LOCATION Hwy 401, 1 km E of
Culloden Rd. - Slope Failure

RE: Review of Contract Drawings and Documents
Highway 401 at Whiting Creek
W.P. 374-94-00
District #31, London/Stratford

Re: Embankment Slope Failure
Highway 401 at Whiting Creek
East of Culloden Road
W.O. 94-11009 (Cont. 92-06, W.P. 374-94-00)
District 2, London

Re: Embankment Slope Failure
Highway 401, 1 km East of Culloden Road
W.O. 94-11009 (Cont. No. 92-06, W.P. 479-89-00)
Geocres 40P2-54
District 2, London

STA. 16+002.5

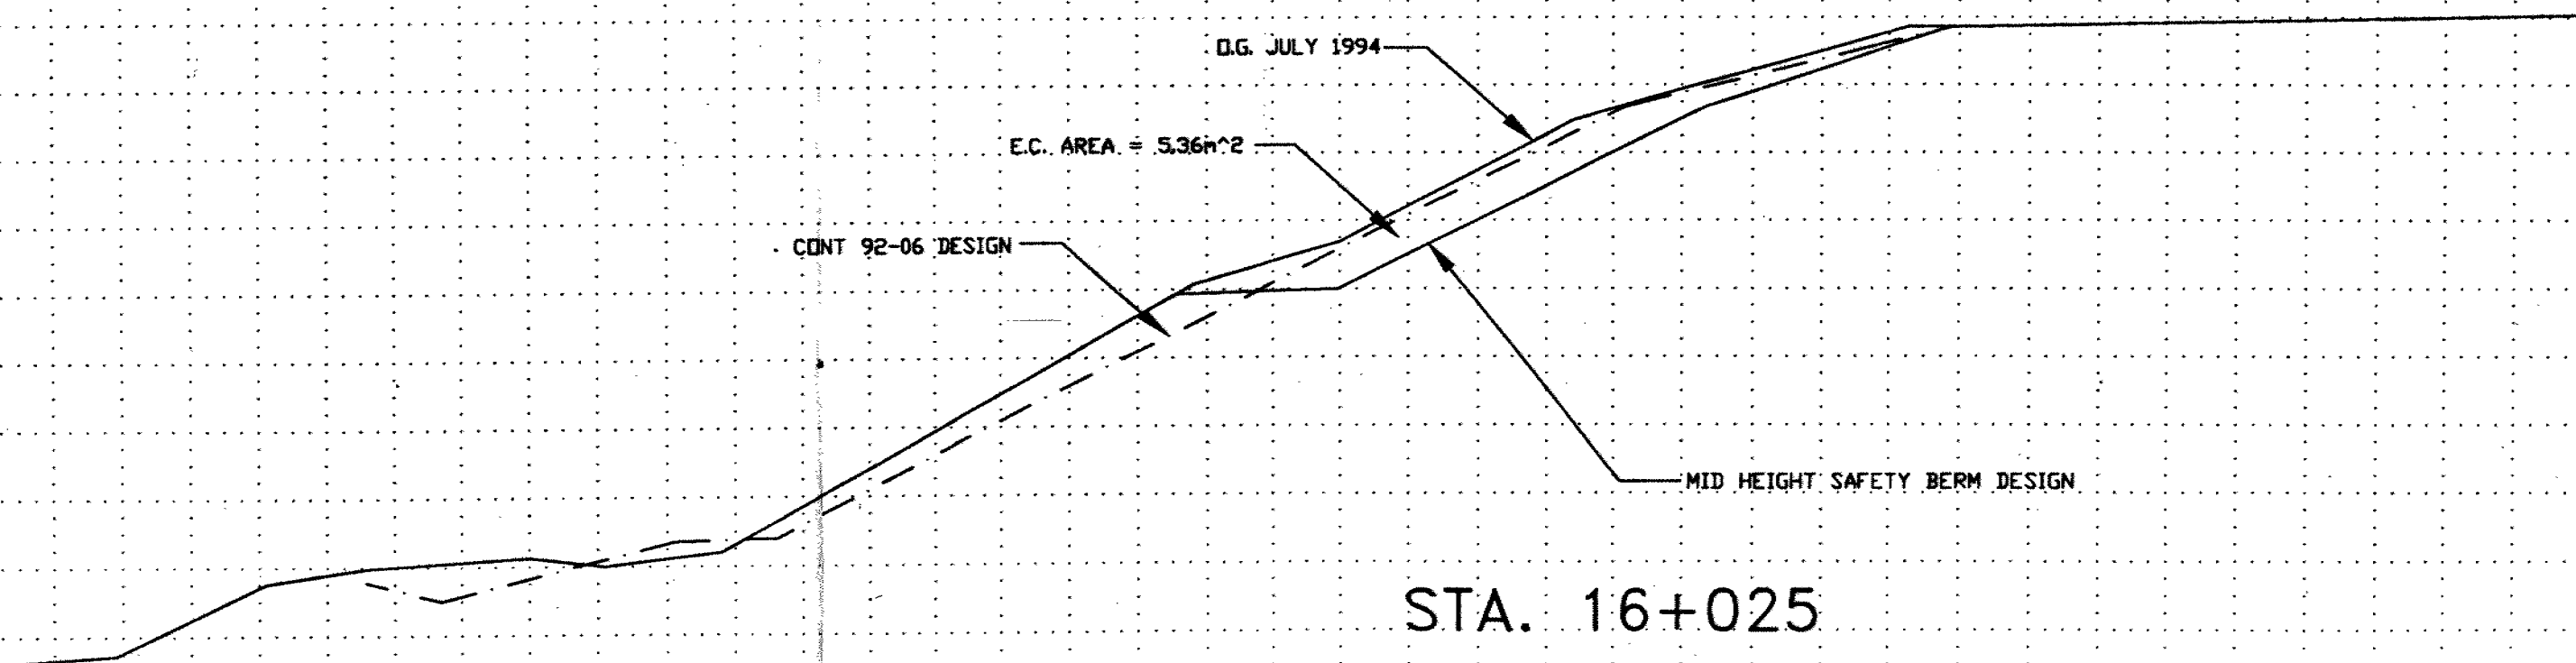
As you are aware, proposed remedial work to these slopes has been delayed until the summer of 1995. The attached cross-sections were surveyed in July 1994 and show the following information.

- Original ground prior to Contract 92-06
- Theoretical widening on the north side of Highway 401 from Contract 92-06 design section rolls
- Ground as determined in July 1994
- Proposed mid height berm design based on maintaining the existing 1.0 m rounding, steepening up the granular side slope behind the guide rail from 4:1 to 3:1, removing the earth fill below the new G/R point at a 2:1 slope, and constructing a safety (mid height) berm at elevation 285.00 m to intersect the original ground

Cross-sections at Sta 15+900, 15+934, 15+970 and 16+025 show material in excess of the Contract 92-06 design line. Towards the end of construction in 1993, surficial failures occurred on both north and south slopes and equipment was used to pull excess material back up the slope. In many cases the G/R point was covered with earth preventing positive seepage from the granular base.

Recommendations presented in your memo dated August 26, 1994 have been discussed on several occasions including representation from Planning and Design, Construction, District and Geotechnical. Based on these discussions, we have the following questions and suggestions for your consideration (recommended remedial measures listed on page 2 of your memo are addressed in numerical order):

- OK
- (1) In order to avoid widening the lower half of the slope, relocation of the ditch and possible purchase of property, we recommend that the lower half of the slope with the exception of trimming and compacting remain as it is. The detail on the cross-section indicates this can be achieved by maintaining the existing 1.0 m rounding, steepening up the granular side slope behind the guide rail from 4:1 to 3:1, removing the earth fill below the new G/R point at 2:1 slope, and constructing a safety berm at about elevation 285.00 m to intersect the original ground. This will mean that the mid height berm will vary in width from 1.6 to 2.8 m, whereas the width recommended in your memo is 2.0 m. OK.

We suggest that a ditch be constructed along the mid-height berm to intercept the runoff water identified in your point 3, therefore eliminating the need for the cutoff trench and subdrain. The ditch would have a longitudinal slope which would outlet to rip-rap lined chutes. Planning and Design proposes to carry out a drainage design to size this mid height ditch and determine whether rip-rap is necessary.

Still need to depress ground water level

still need subdrain

GRANULAR BLANKET

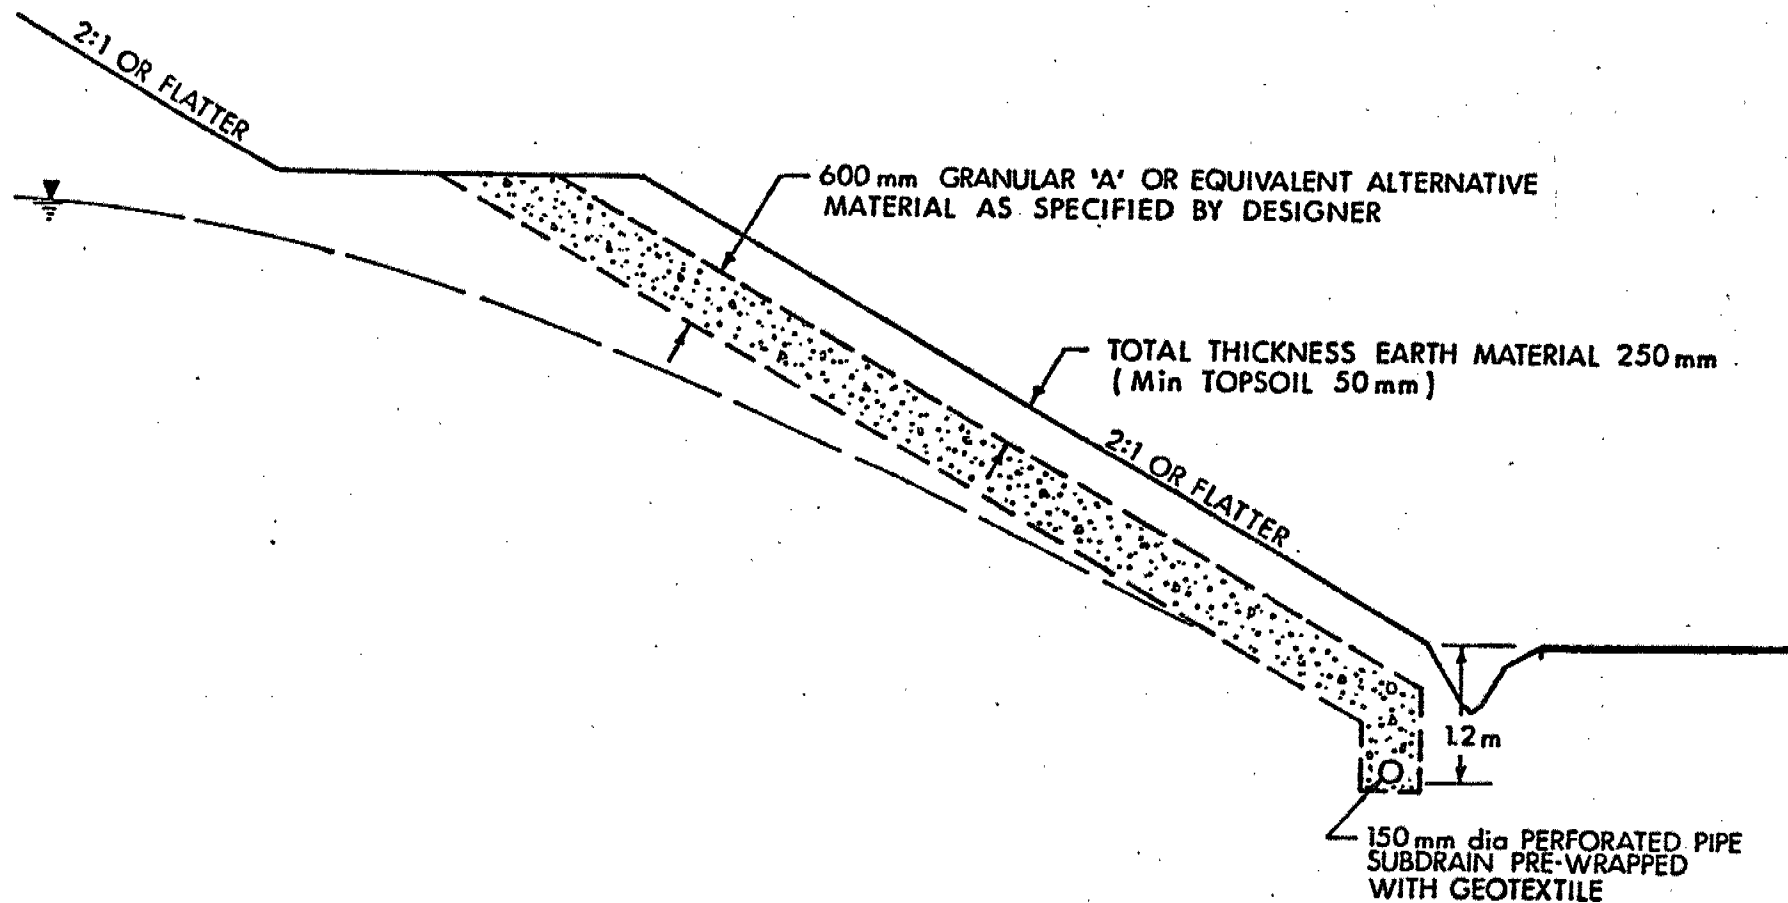
As discussed at the meeting, alternatively, Gravel sheeting or Granular blankets can be used where groundwater flow must be controlled to ensure slope stability. However, Granular blankets do not adequately sustain vegetation cover since granular materials promote moisture depletion and do not contain sufficient nutrients.

The attached figure is a detail summarizing the consensus reached during the meeting with the landscape unit of the Central Region. It incorporates a sufficient thickness of earth and topsoil (250 mm) to meet architecture requirements while providing drainage to ensure slope stability.

WO 94-11009
Geocres No 40P2-54
Fig. 1

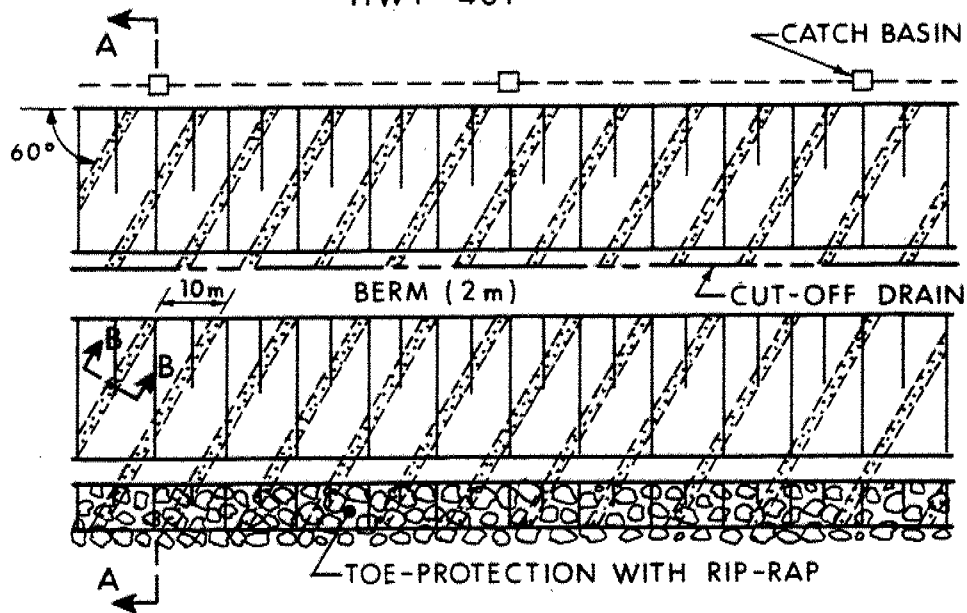
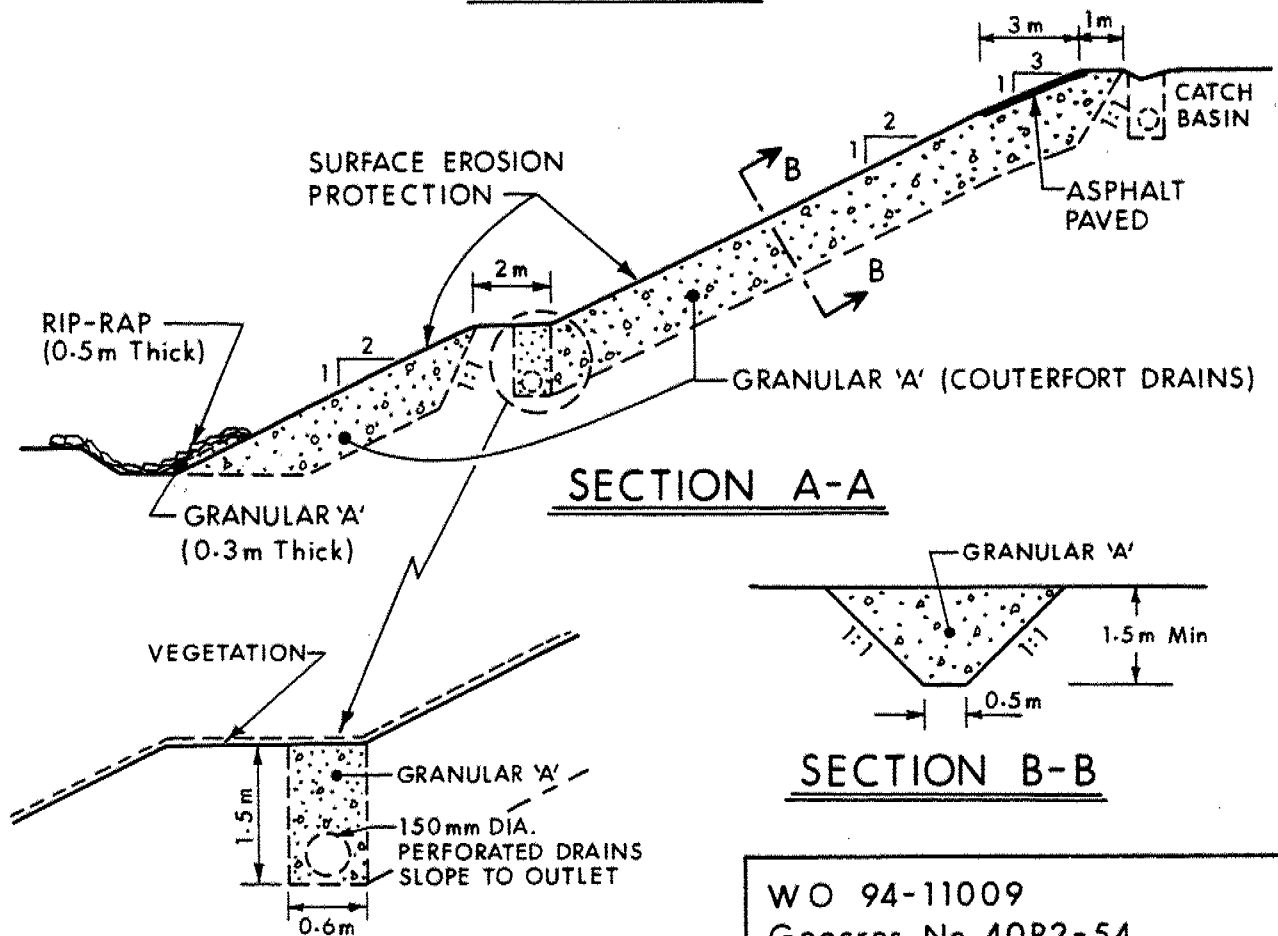
- 1) All of the unstable and/or loosened material in the area where the slippage has occurred should be removed and restored to a slope with a geometry not steeper than 2H:1V with a 2 m mid-height safety berm along the entire length of the fill slope, as shown on Figure 1. The fill should be keyed into the pre-existing slope in accordance with current MTO Standards and practice (OPSD 208.01).

- 2) Concrete curb or asphalt gutter with catch basins should be constructed along the crest of the upper slope on the shoulder of the highway.
- 3) An adequate cut-off trench (base width of 0.6 m) should be constructed along the crest of the mid-height berm in order to intercept the runoff water. A 150 mm diameter perforated subdrain pipe should be installed within the cut-off trench as shown on Figure 1.

- 5) Diagonal counterfort drains at least 1.5 m deep and having a minimum base width of 0.5 m should be constructed from the limit of the fill slope to the toe of the slope. The spacing of these drains should be about 10 m from centre to centre at their upper surface. The material used for the drains should consist of free-draining granular material, such as Granular "A". The details of the counterfort drains are shown on Figure 1 attached.

SLOPE FAILURE RECOMMENDATIONS:

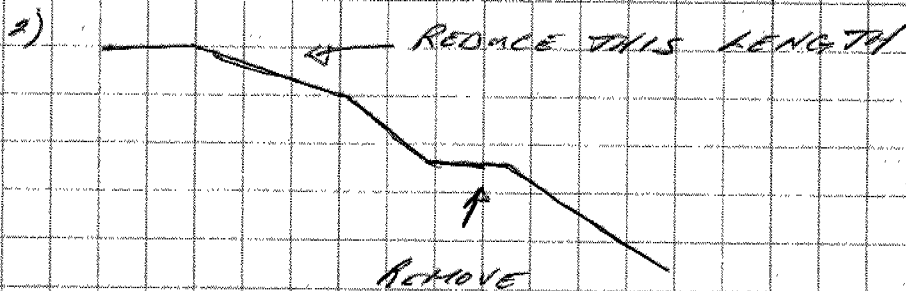
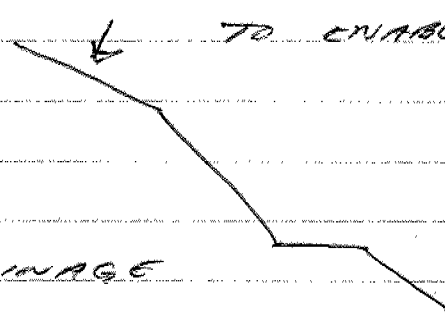
1) WALL (CONCRETE) OR ASPHALT GUTTER
WITH CATCH BASINS

AND ADD ANGLED DITCHES ALONG
SLOPE LINED WITH RIPRAP.

① RECOMMEND SLOPE DRAINS WITH STEP

AT MID POINT.

REDUCING SLOPE AT TOP
A LONGER SLOPE

② CONCRETE WALL WITH DRAINAGE
